**Proposal for amendments to the Consolidated Resolution on the Construction of Vehicles (R.E.3) submitted by the Working Parties to the World Forum for consideration**

## **Proposal for an amendment to Annex 4 to the Consolidated Resolution on the Construction of Vehicles (R.E.3)**

### **Submitted by the Working Party on Pollution and Energy\***

The text reproduced below was adopted by the Working Party on Pollution and Energy (GRPE) at its seventy-ninth session (ECE/TRANS/WP.29/GRPE/79, para. 72). It is based on ECE/TRANS/WP.29/GRPE/2019/13. It is submitted to the World Forum for Harmonization of Vehicle Regulations (WP.29) and to the Administrative Committee AC.1 for consideration at their November 2019 sessions.

Figure A4-1:  
Relation between vapour pressure (VP), E70 and VLI for the ten different volatility classes for unleaded petrol with a maximum oxygen content of 2.7% (m/m).

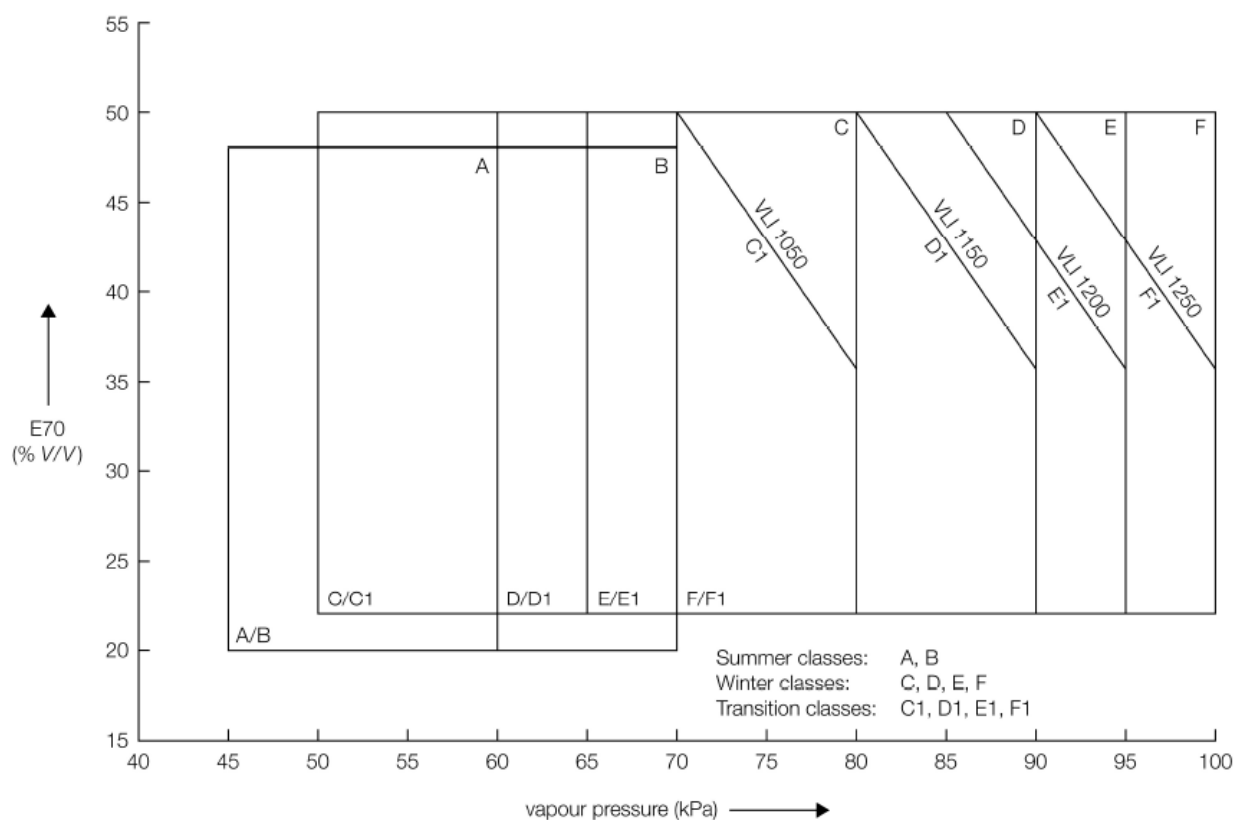
## 7.2.1. Volatility Classes for Unleaded Gasoline (R83.03, R83.05, R83.06, R83.07 – E5 gasoline blend)

Class <sup>(*)</sup>	A	B	C/C1	D/D1	E/E1	F/F1
Vapour pressure (kPa)	45 - 60	45 - 70	50 - 80	60 - 90	65 - 95	70 - 100
E70 (%) <sup>1</sup>	20 - 48	20 - 48	22 - 50	22 - 50	22 - 50	22 - 50
E100 (%) <sup>1</sup>	46 - 71	46 - 71	46 - 71	46 - 71	46 - 71	46 - 71
E150 (% min) <sup>1</sup>	75	75	75	75	75	75
Final boiling point (°C max) <sup>1</sup>	210	210	210	210	210	210
T10 (°C) <sup>1</sup>	65	60	55	50	45	45
T50 (°C) <sup>1</sup>	77 - 100	77 - 100	75 - 100	70 - 100	65 - 100	65 - 100
T90 (°C) <sup>1</sup>	130 - 175	130 - 175	130 - 175	130 - 175	130 - 175	130 - 175
Distillation residue (% V/V, max)	2	2	2	2	2	2
Vapour Lock Index (VLI) (10 VP + 7 E70) (index max)	-	-	C	D	E	F
Vapour Lock Index (VLI) (10 VP + 7 E70) (index max)			C1 1 050	D1 1 150	E1 1 200	F1 1 250

Figure A4-2:  
**Relation between vapour pressure (VP), E70 and VLI for the ten different volatility classes for unleaded petrol with a maximum oxygen content of 3.7% (m/m).**

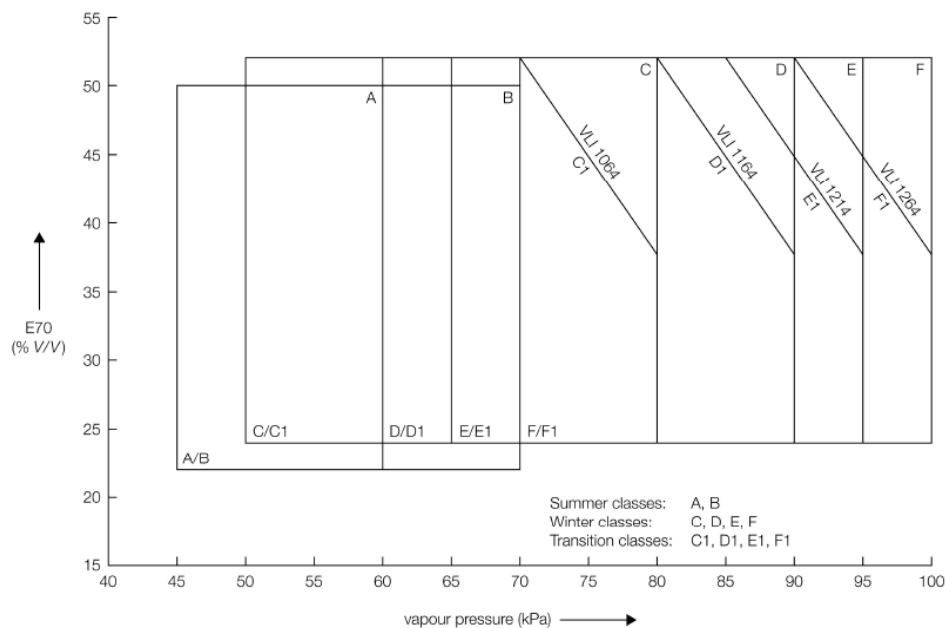
7.2.2. Volatility Classes for Unleaded Gasoline (R83.07 - E10 gasoline blend)

Class (*)	A	B	C/C1	D/D1	E/E1	F/F1
Vapour pressure (kPa)	45 - 60	45 - 70	50 - 80	60 - 90	65 - 95	70 - 100
E70 (%) <sup>1</sup>	22 - 50	22 - 50	24 - 52	24 - 52	24 - 52	24 - 52
E100 (%) <sup>1</sup>	46 - 72	46 - 72	46 - 72	46 - 72	46 - 72	46 - 72
E150 (% min) <sup>1</sup>	75	75	75	75	75	75
Final boiling point (°C max) <sup>1</sup>	210	210	210	210	210	210
T10 (°C) <sup>1</sup>	65	60	55	50	45	45
T50 (°C) <sup>1</sup>	65 - 100	65 - 100	65 - 100	65 - 100	65 - 100	65 - 100
T90 (°C) <sup>1</sup>	130 - 175	130 - 175	130 - 175	130 - 175	130 - 175	130 - 175
Distillation residue (% V/V max)	2	2	2	2	2	2
Vapour Lock Index (VLI) (10 VP + 7 E70) (index max)	-	-	-	-	-	-
Vapour Lock Index (VLI) (10 VP + 7 E70) (index max)			C1 1 064	D1 1 164	E1 1 214	F1 1 264
